EXTRAORDINARY LOCAL TRAFFIC COMMITTEE MEETING

EXTRAORDINARY LOCAL TRAFFIC COMMITTEE MEETING MINUTES 8 DECEMBER 2020

REPORT OF THE EXTRAORDINARY LOCAL TRAFFIC COMMITTEE MEETING HELD ON TUESDAY, 8 DECEMBER 2020

Figure 1 – location of requested yellow lines.

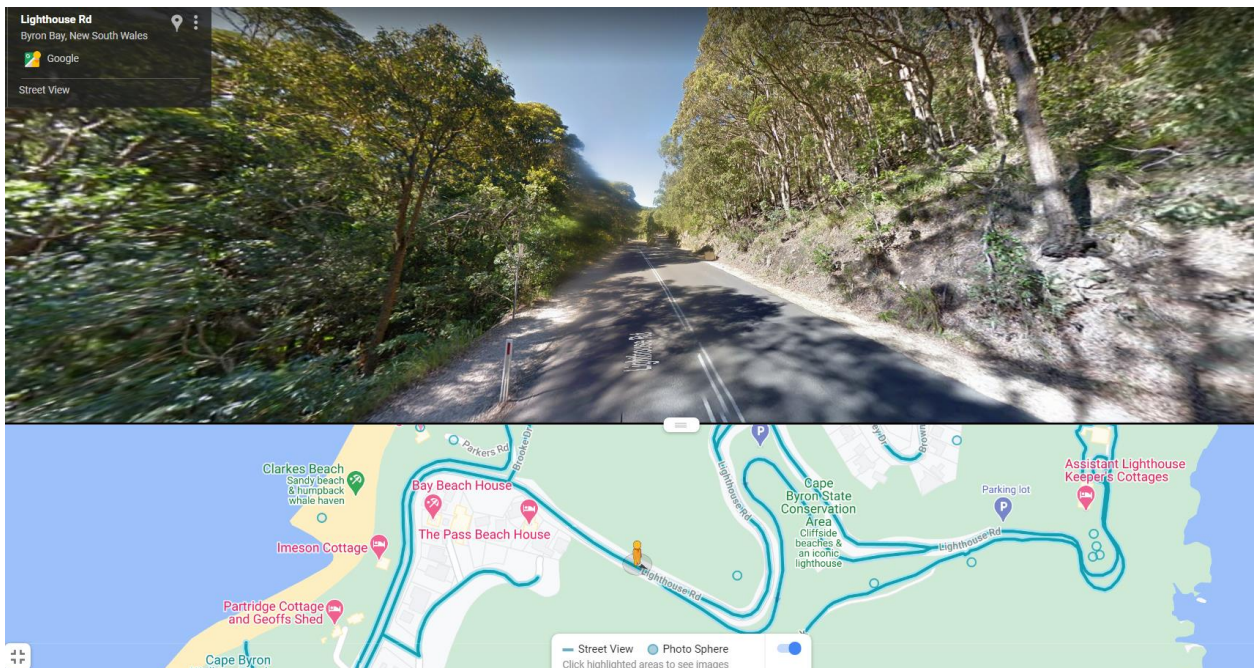
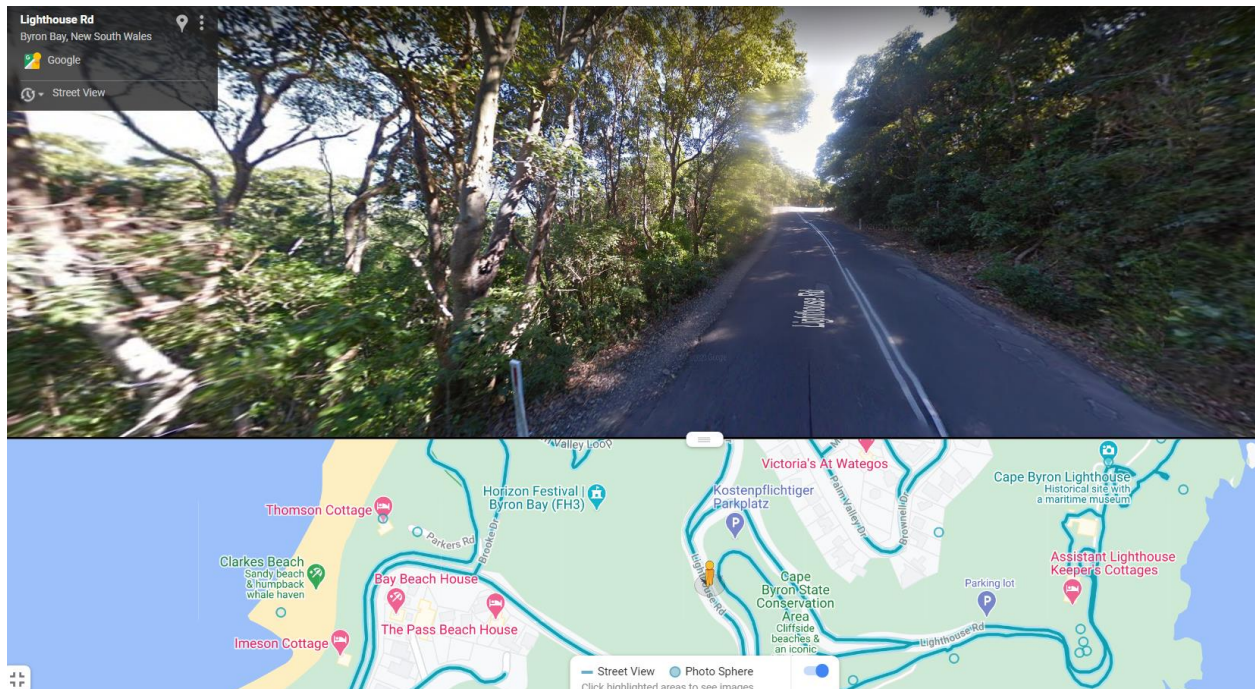
Shanahan: it appears that the road has 'no parking' signs both sides, what is going to happen to these signs? Take them out or replace with 'no stopping' signs? Otherwise no issues.

Kehoe: I support the installation of 'No Stopping' signs in conjunction with yellow lines to ensure compliance along Lighthouse Road.

Elford: Council has sufficient budget to enable the existing signs to be replaced with "No Stopping" so once the matter is voted we will undertake the lines and sign changes – I suggest that the recommendation be modified to read:

LTC recommends Council change "No Parking" signs to "No Stopping" in conjunction with the provision of yellow line marking in Lighthouse Road, Byron Bay.

- 1. Endorse the installation of yellow lines along Lighthouse Road from the Brooke Drive intersection extending through to the start of Palm Valley Drive.**
- 2. Change "No Parking" signs to "No Stopping" in conjunction with the provision of yellow line marking in Lighthouse Road, Byron Bay.**
